4.2 S75W ADJUSTMENTS SCHEME ADJUSTMENT MASSING

4.3 S75W ADJUSTMENTS PROPOSED CONCEPT PLAN SCHEME

4.7 S75W ADJUSTMENTS SCHEME COMPARISON COOLINGA ST ENTRY

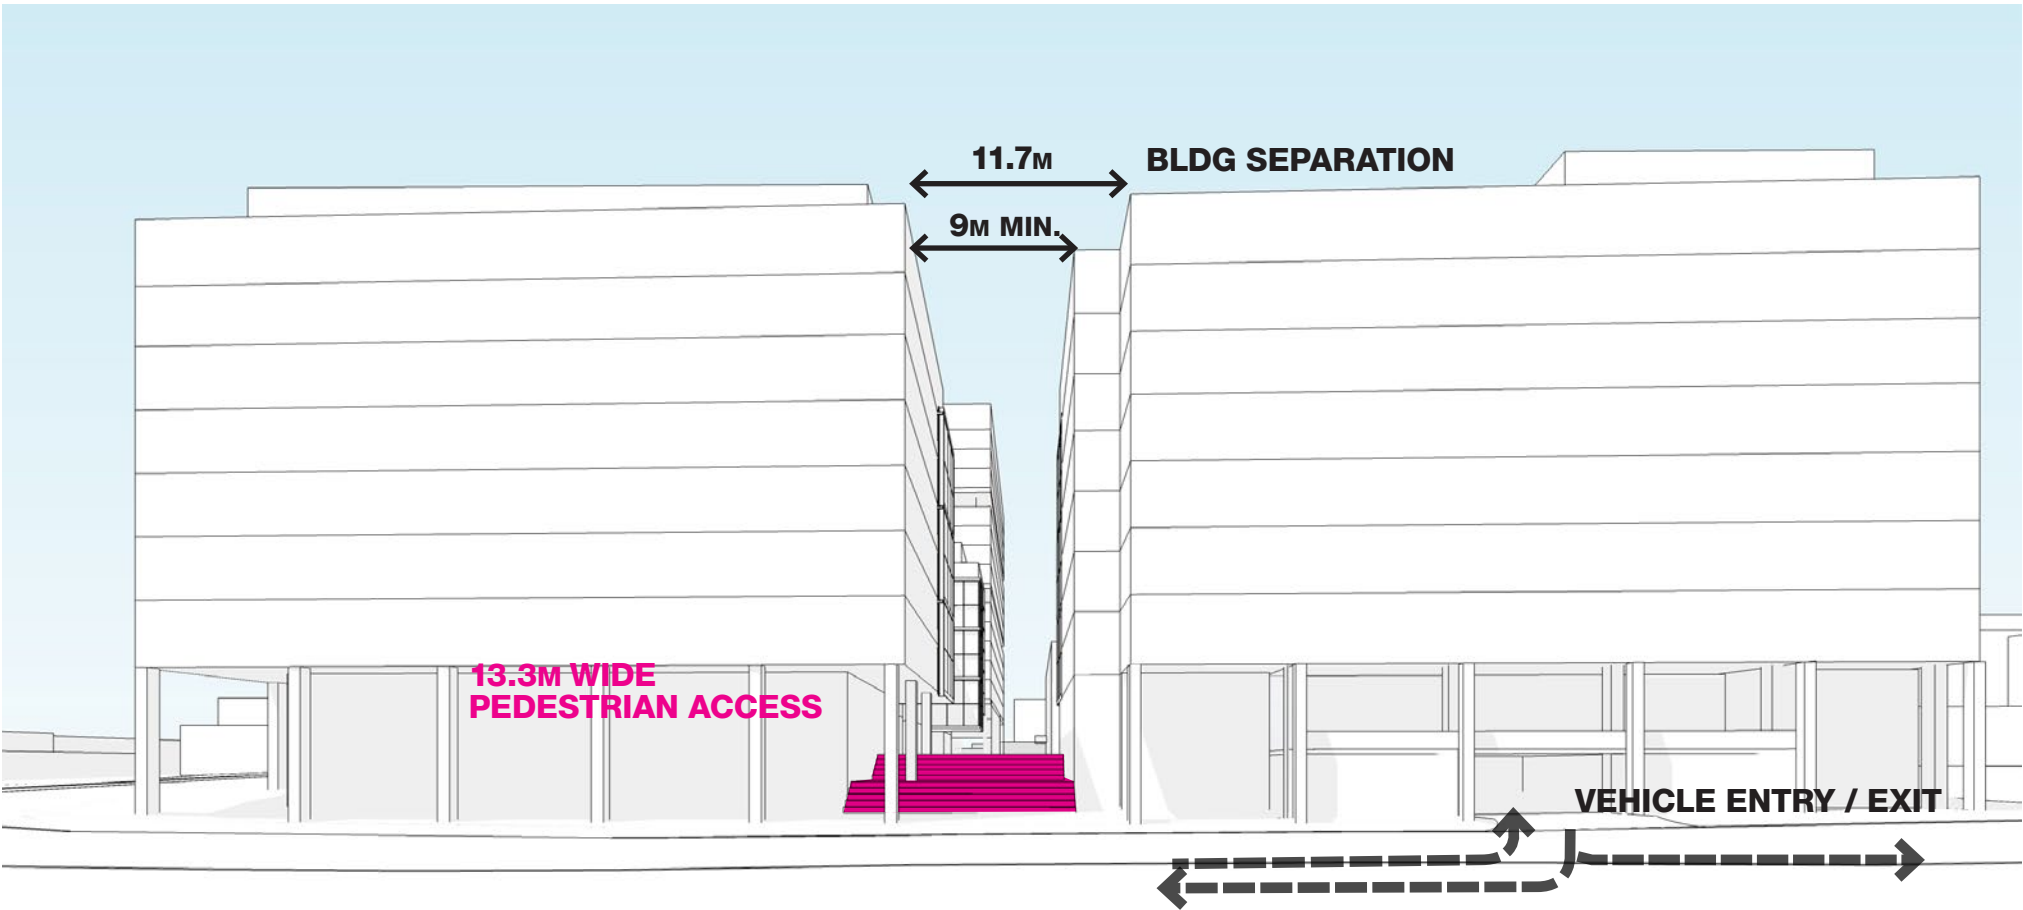
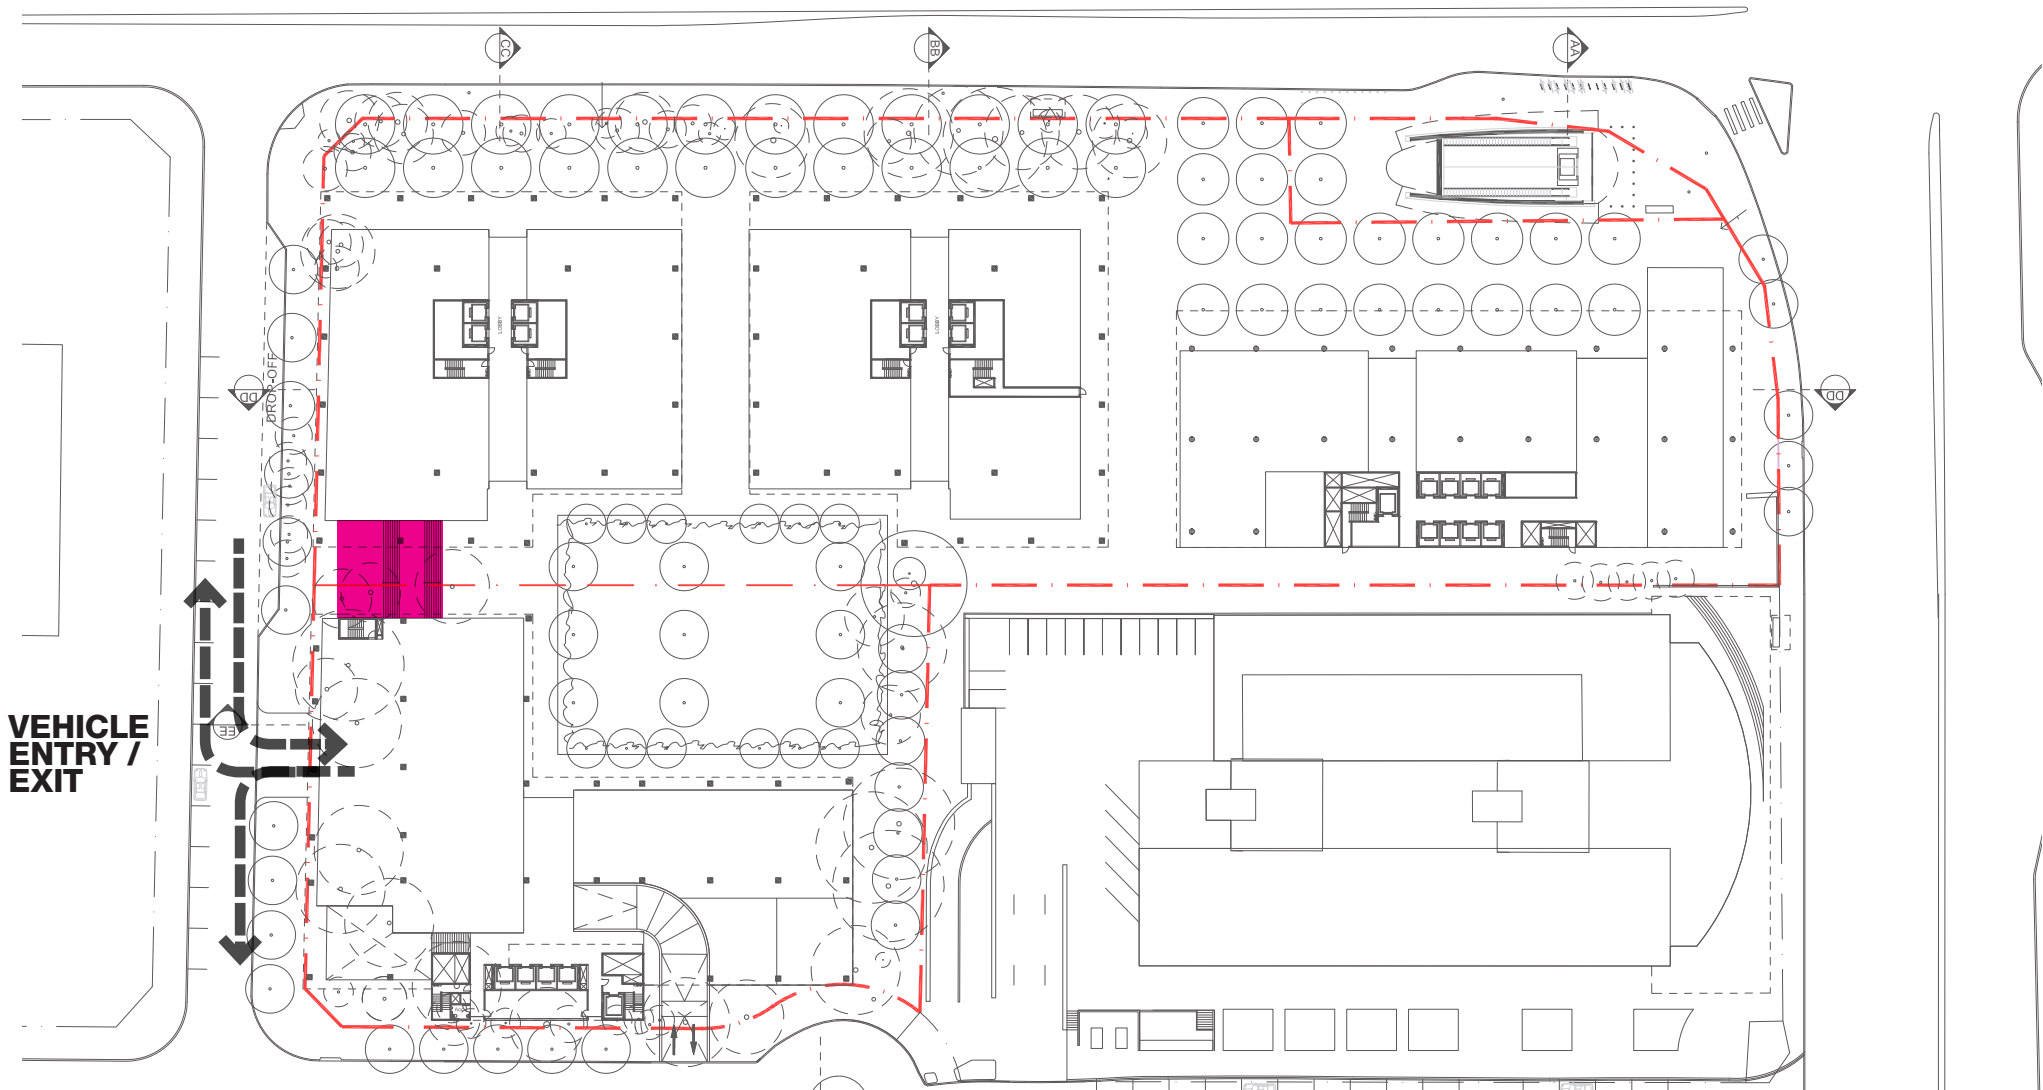
The following diagrams describe the amendments and improvements to the Coolinga Street entry in the Section 75W submission.
The pedestrian thoroughfare width has increased by 9m as a result of the vehicle carpark entry re-location to within the building facade.

4.8 S75W ADJUSTMENTS SCHEME COMPARISON LANEWAYS

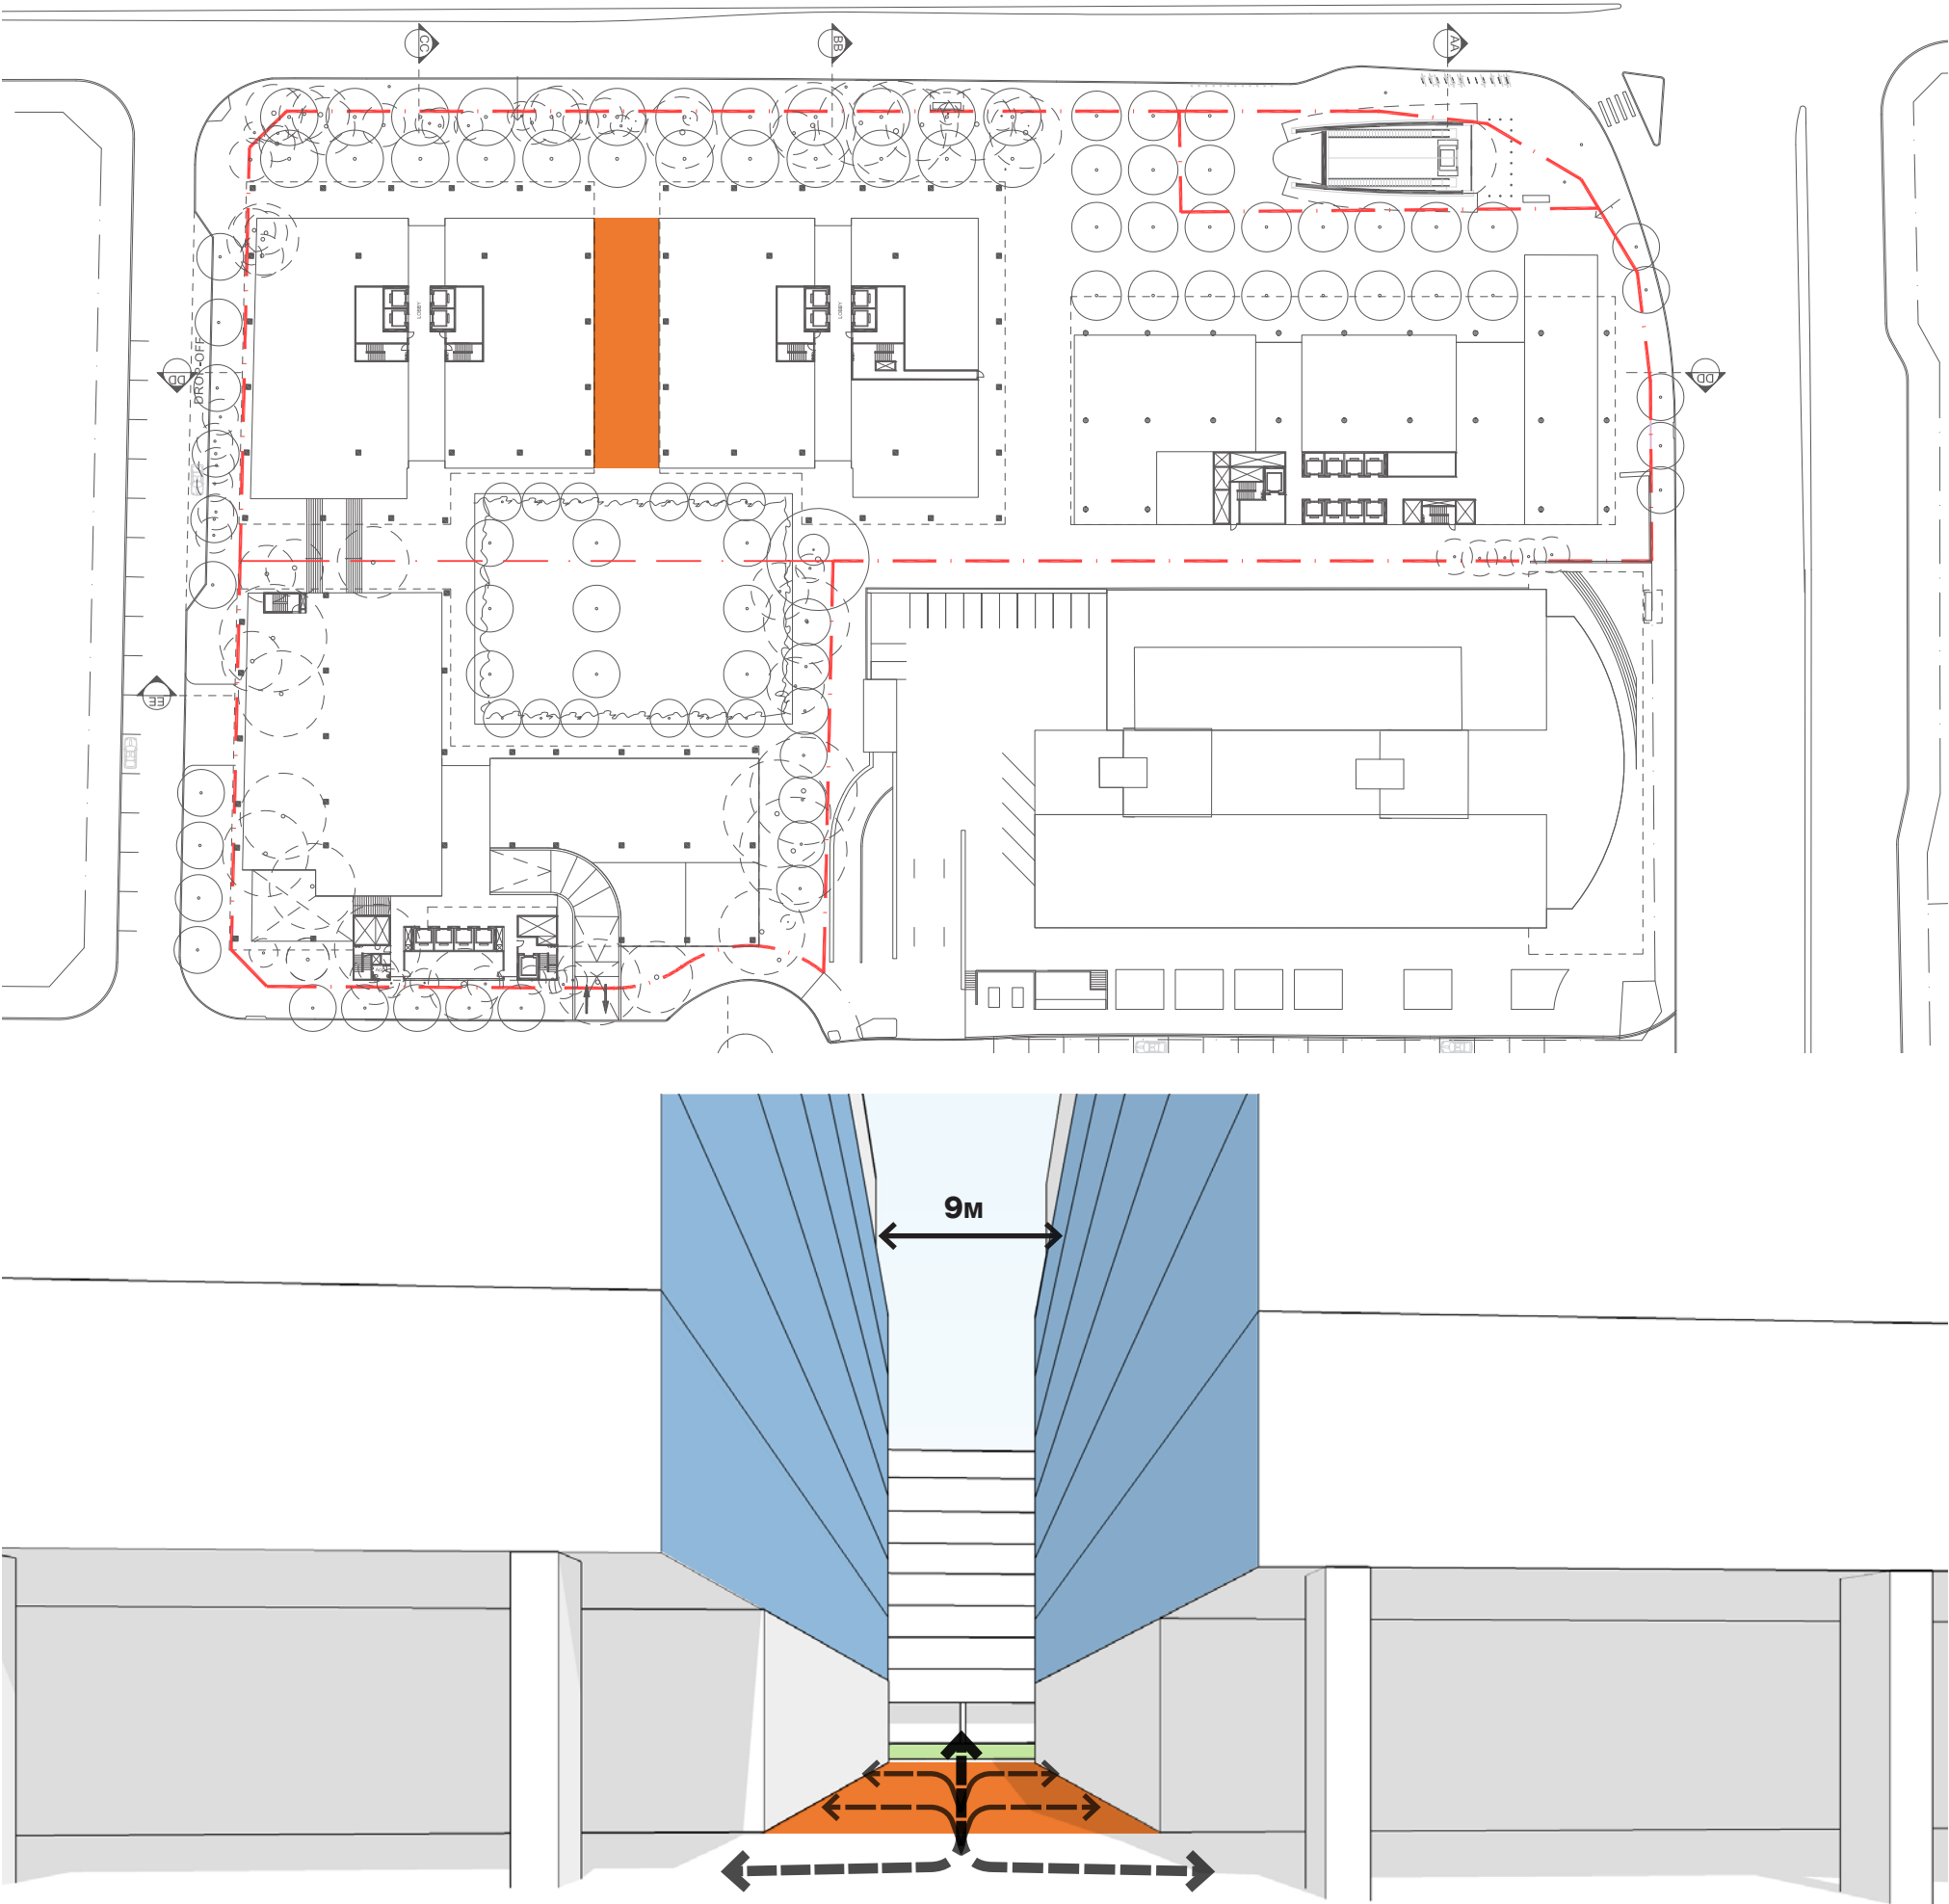
The following diagrams describe the amendments and improvements to the laneway connections in the Section 75W submission.
The laneway widths have reduced from 15m to 9m and the large trees and landscaping removed to create a single path of thoroughfare effectively increasing opportunities for retail to be more intimate, usable and vibrant.
